## FIELD CHANGE NOTICE

### Gang Socket Redesign

July 2009

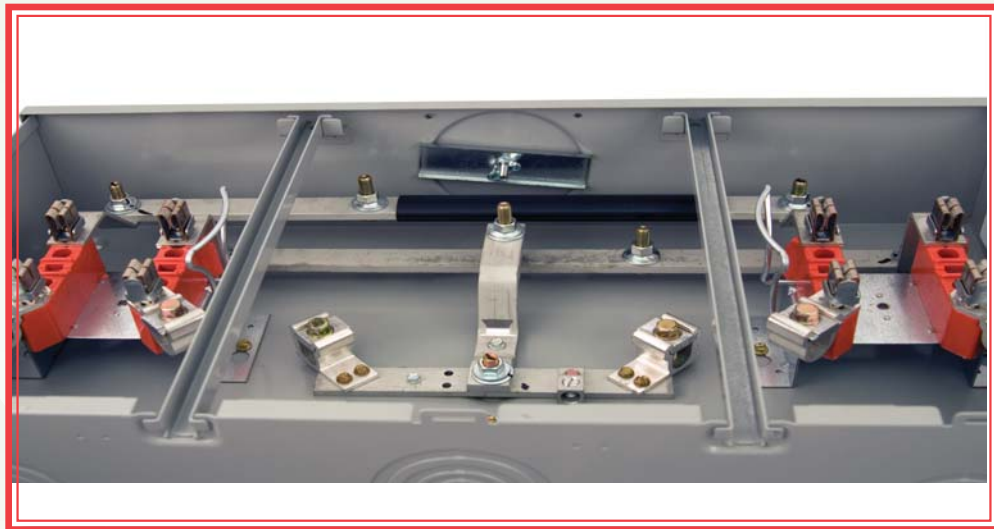
Milbank recently updated the design of our gang sockets to aid in the ease of assembly at our factory. We also took this opportunity to increase the spacing between the bus bars, allowing us to eliminate most of the black sleeving that we previously supplied. The only piece of sleeving that is required is located on the upper bus under the overhead entrance KO. This piece of sleeve will prevent the bare neutral conductor from contacting the live bus. Refer to the picture below as an illustration of the new design.

The increased spacing and removal of the black sleeving has been fully tested and is UL listed. The list of affected model numbers are; U1232-U1236, U1252-U1256, U1282-U1286, U3522-U3526 & U3763-U3765.
